SERVICE DIRECTIVE BULLETIN NO. 0090

Revision 3

DATE: June 5, 2024

1. SUBJECT: 12 Vdc Voltage Control System Modification

FIGURE 1. VOLTAGE CONTROL INSTALLATION IN SEAT STRUCTURE

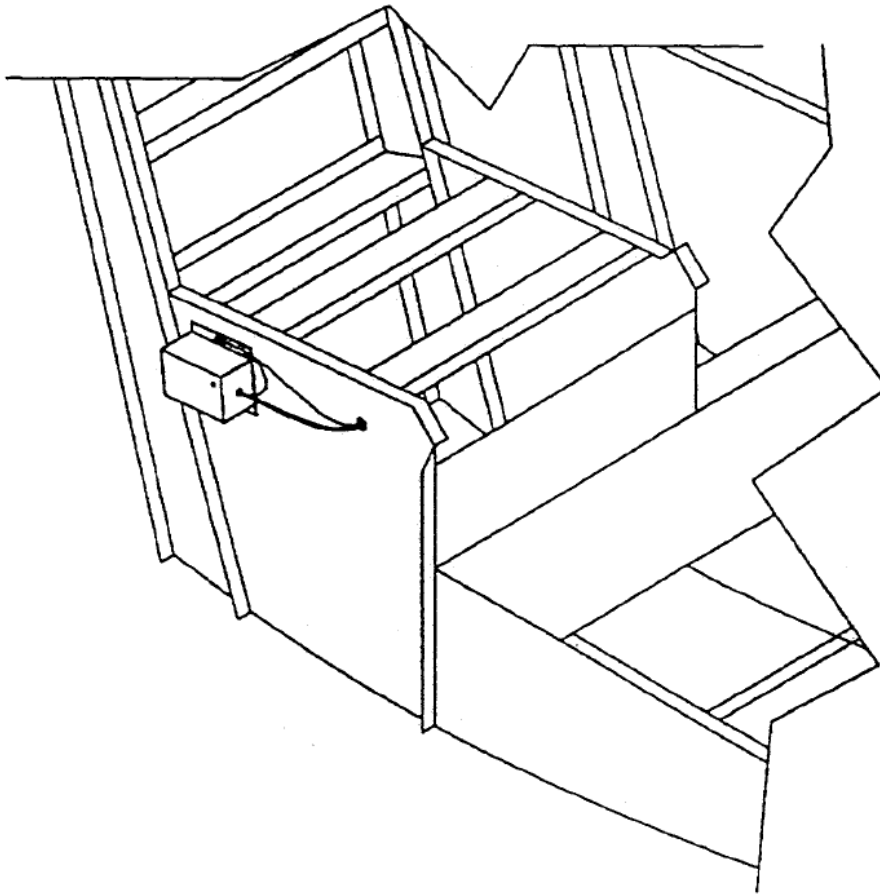
- 5.2.3.3. Install the voltage control on the outside of the seat structure as far aft as possible and with the edge of the mounting flange 1 inch/2.5 cm from the top of the seat structure (refer to Figure 1). If the voltage control interferes with the battery installation in this position, the voltage control may be installed on the inboard side of the seat structure. Remove any paint and clean the area around the top mounting hole in the seat structure to provide a case/terminal ground. Apply CP8-TB Kopr-Shield on mounting flange of the voltage control and on the bare metal mounting surface.

- NOTES:
1. Install the voltage control on the outside of the seat structure as far aft as possible with the edge of the mounting flange 1 inch/2.5 cm from the top of the seat structure. Install the voltage control on the inside of the seat structure if it interferes with the battery installation.
 2. Install an AN931-4-7 Grommet in the seat structure as required for wiring installation.
 3. Remove any paint and clean the area around the top mounting hole in the seat structure to provide a case/terminal ground. Apply CP8-TB Kopr-Shield on mounting flange of the voltage control and on the bare metal mounting surface.
 4. Use hardware listed in Paragraph 6.1 to install the voltage control.

FIGURE 2. VOLTAGE CONTROL INSTALLATION

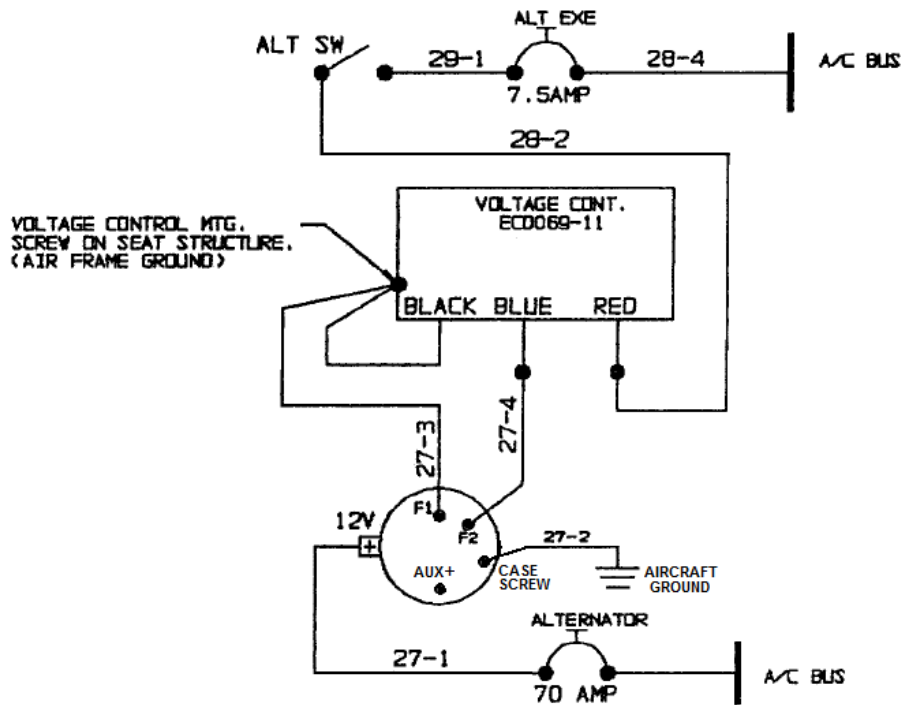
- 5.2.3.4. Refer to Figure 2 and install the electrical wiring for the voltage control, alternate switch, and the “ALT EXC.” circuit breaker.
- 5.2.3.5. If required, reinstall the battery.

- NOTES:
1. If the "ALT EXC." circuit breaker is already installed in the aircraft, disregard note 2 and do not modify the wiring from the bus side of the "ALT SW" to the aircraft bus.
 2. Connect wire 28-4 to the aircraft bus at one of the installed circuit breaker bus terminals.
 3. Connect the "BLACK" lead of the voltage control and wire 27-3 to the case ground/seat structure.
 4. Use 16 Gauge wire as required.
 5. F1 at alternator and the black lead of voltage control must be at the same ground potential.
 6. Connect the ground wire 27-2 to case ground. Do not connect it to the AUX+ terminal
 7. All wiring to be accomplished in accordance with AC 43B-1A.
